CONSTRUCTION SUMMARY

Forestside Estates Inc.

LOT NUMBER	PHASE	HOUSE TYPE	CLOSING DATE	
244 BLOCK 5	6-III	Blue Ash 2A2a	01-May-23

Purchasers	Decor Consultant	Model and Elevation	Telephone Res. / Bus	Project	Closing Date	Property
	ANDEEP SINGH BUDHIRAJA & HARLEEN KAUR BUDHIRAJA	Denise Sue	Blue Ash 2A2a	/	Forestside Estates Inc.	01/05/2023	244 BLOCK 5

* STD APPLIANCE ⊕ KITCHEN
PACKAGE

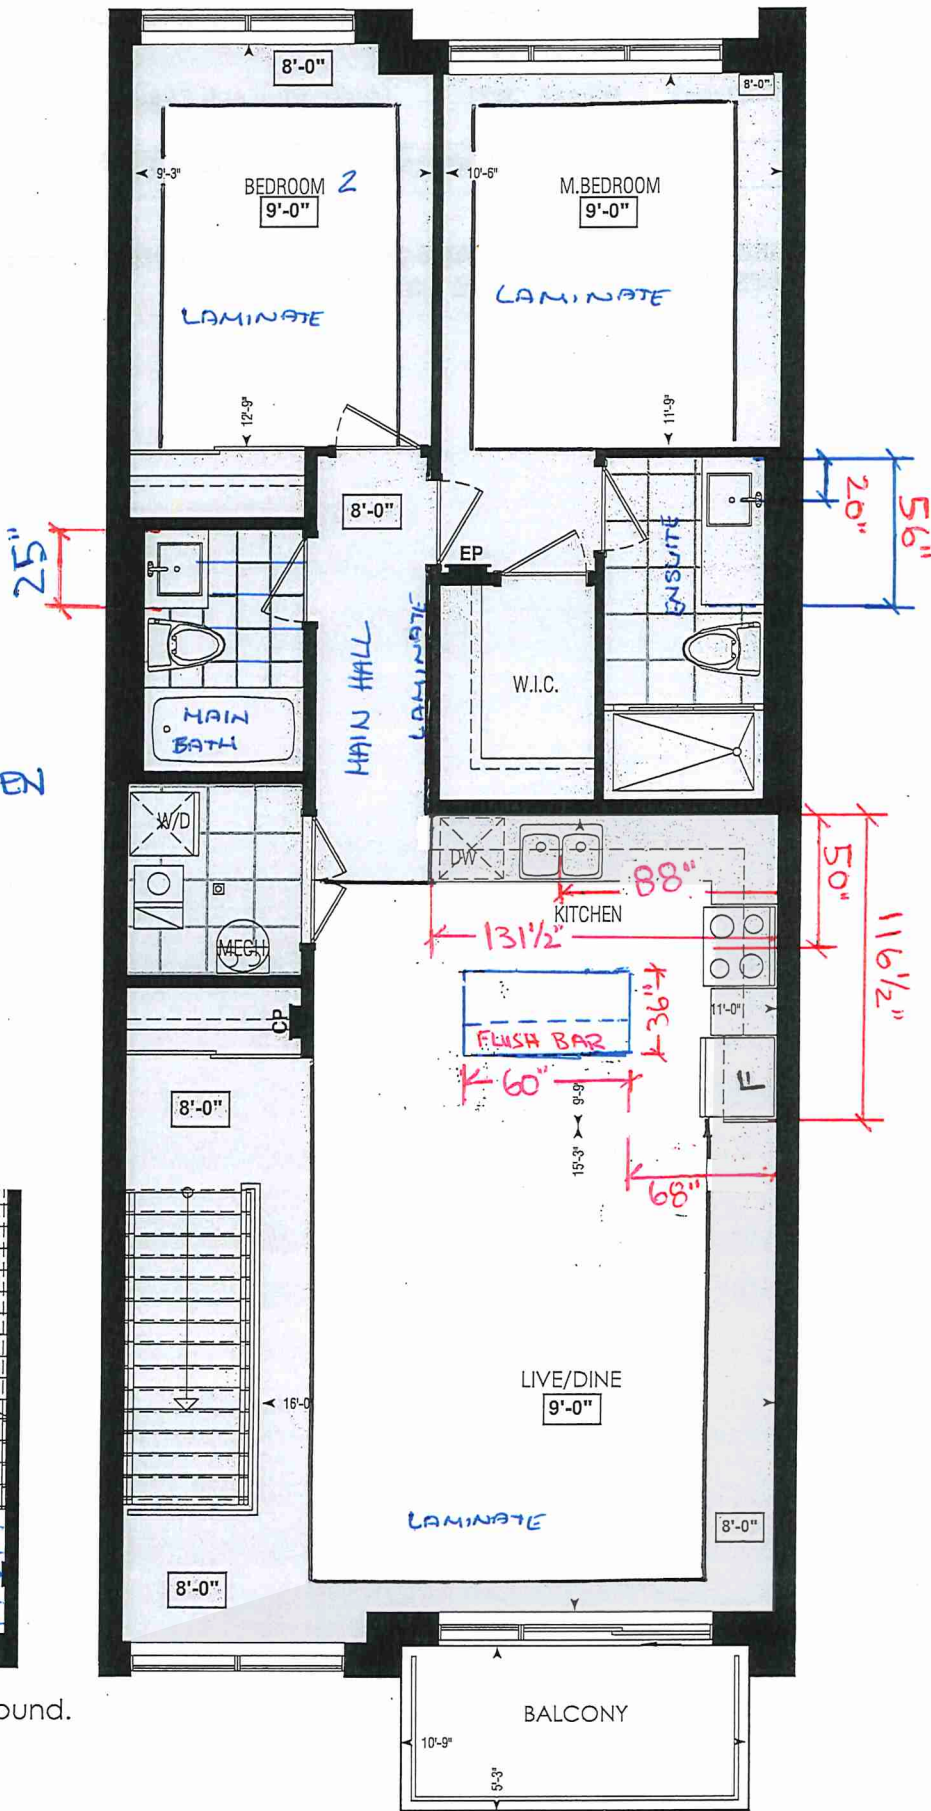
1 - APPLIANCE PACKAGE- Install the Standard Appliance Package. To be installed throughout the suite, where applicable (See Sketch)

1 - MASTER BEDROOM - FLOORING - Install UPGRADED LAMINATE throughout the master bedroom where applicable in lieu of the builder's standard broadloom. Install 8" HIGHLAND WATSON NATURAL OAK EE-H-292(See sketch)
Note: To include applicable shoe moulding

1 - BEDROOM 2- FLOORING - Install UPGRADED LAMINATE throughout bedroom #2 where applicable in lieu of the builder's standard broadloom. Install 8" HIGHLAND WATSON NATURAL OAK EE-H-292(See sketch)
Note: To include appliacle shoe moulding

KITCHEN PLAN

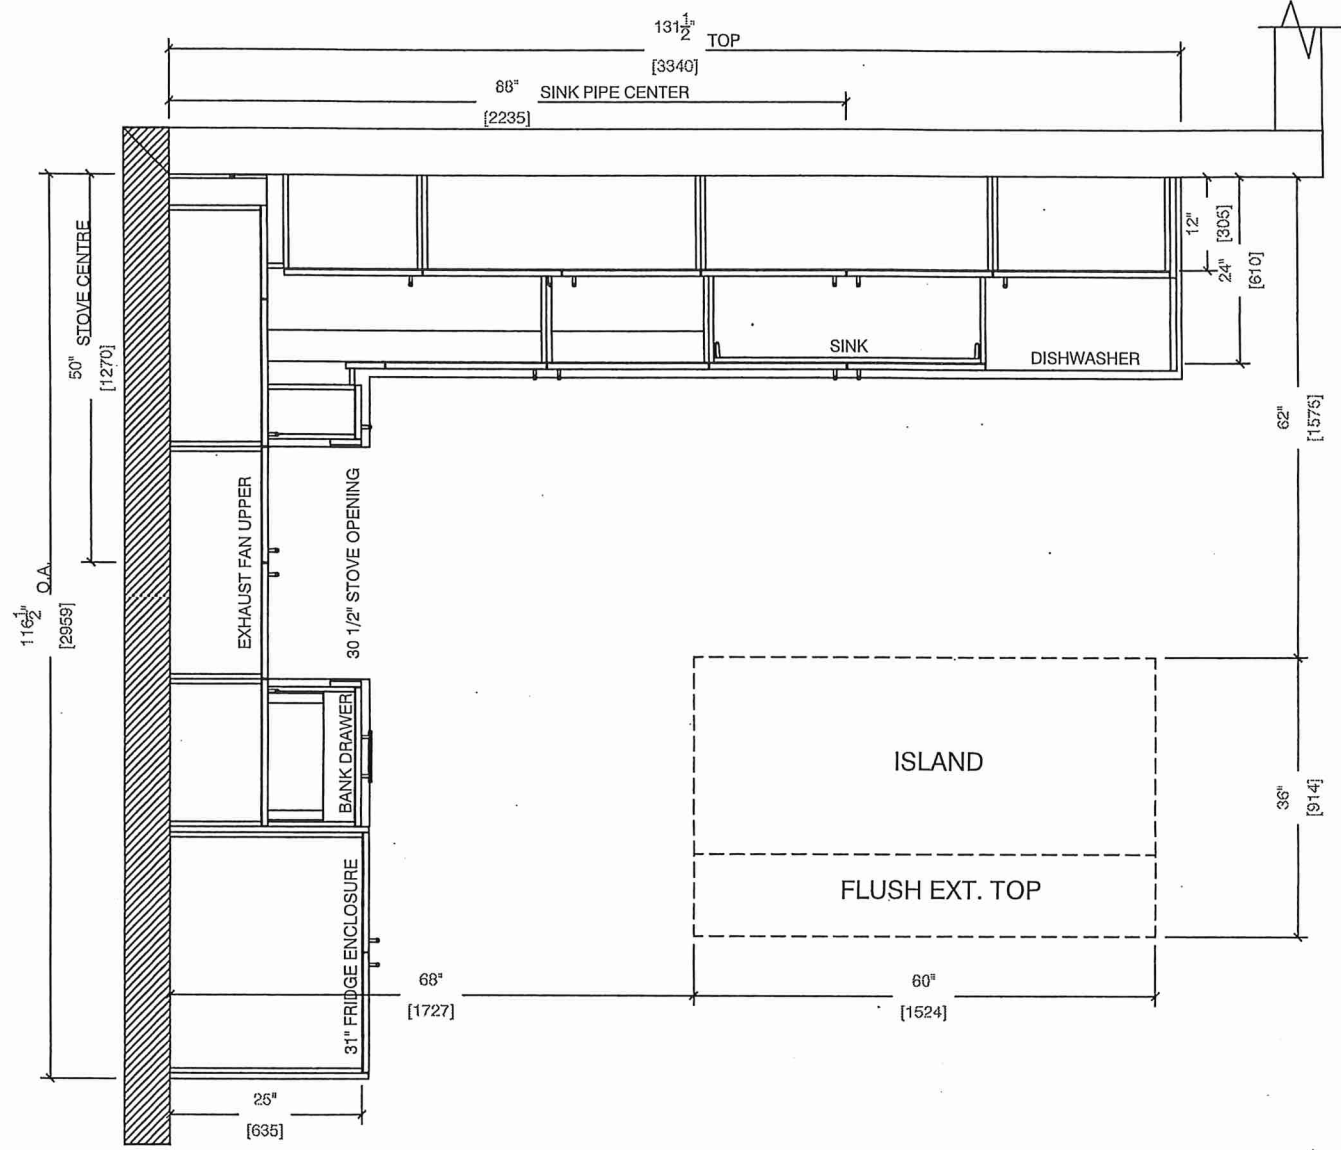
1 - KITCHEN - CABINETRY- Install OPTIONAL ISLAND in the kitchen layout where applicable. To include pot and pan drawer. (See Sketch)

1 - KITCHEN - COUNTER - Install STONE COUNTERTOP overtop of the optional kitchen island. To be installed with the standard "A" Edge. (See Sketch)

SINK WALL ELEVATION

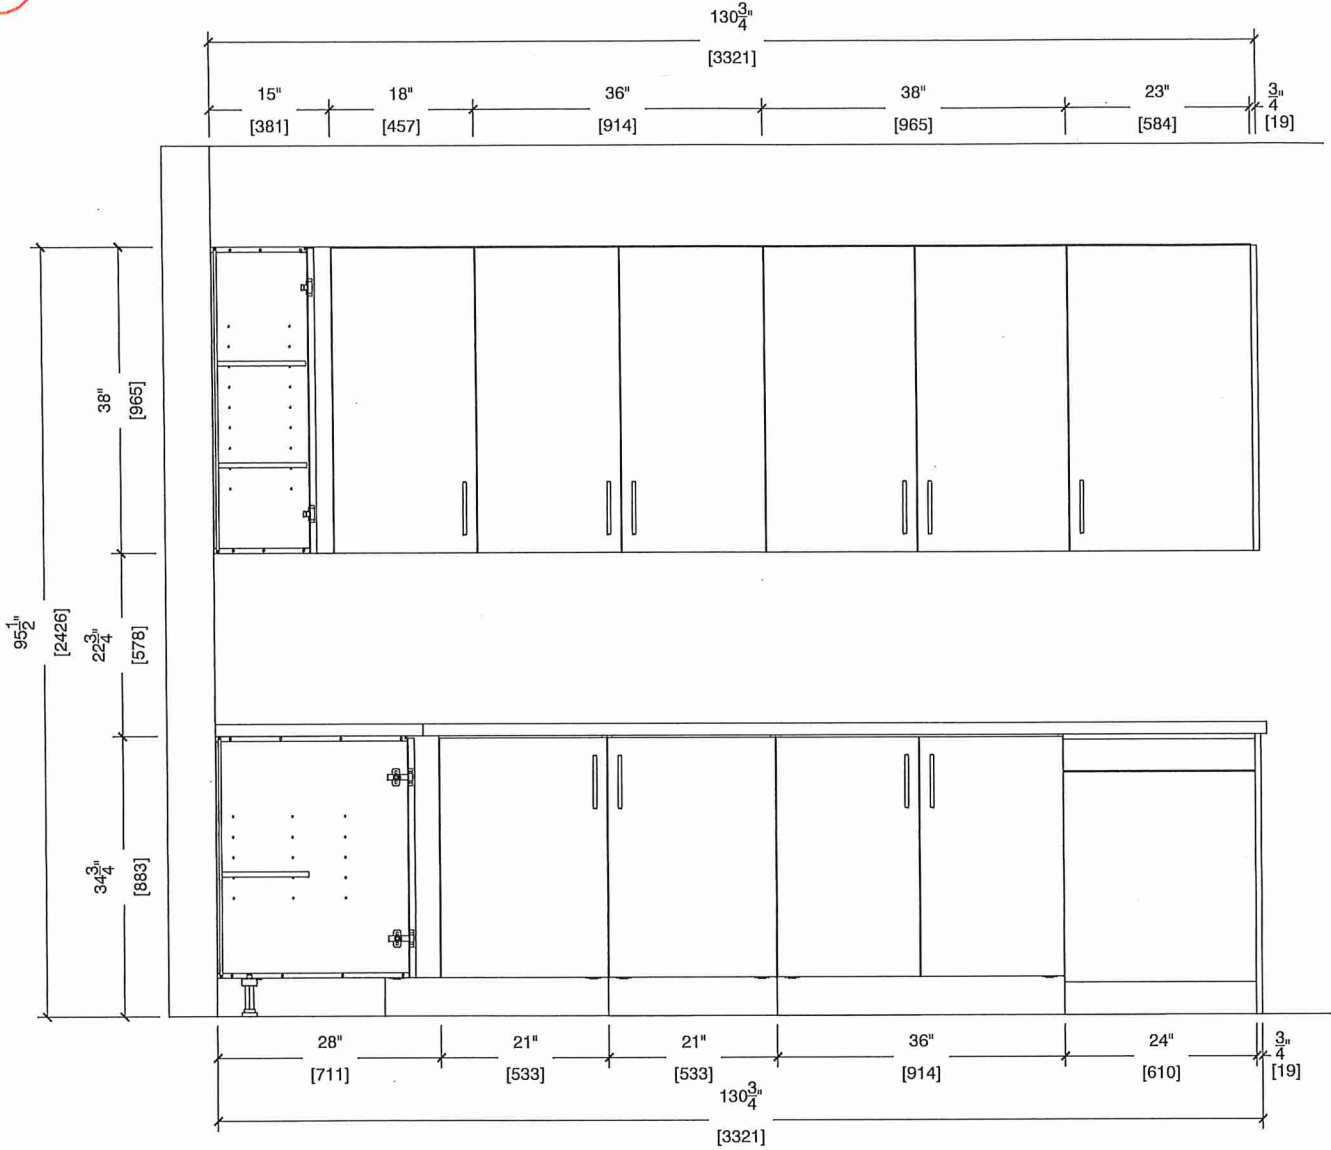
1 - KITCHEN-PLUMBING - Install the builders standard Top mount sink in the kitchen- Install the BLANCO HORIZON 2.0 (7") Top mount Sink- Model # 401124 (see sketch)
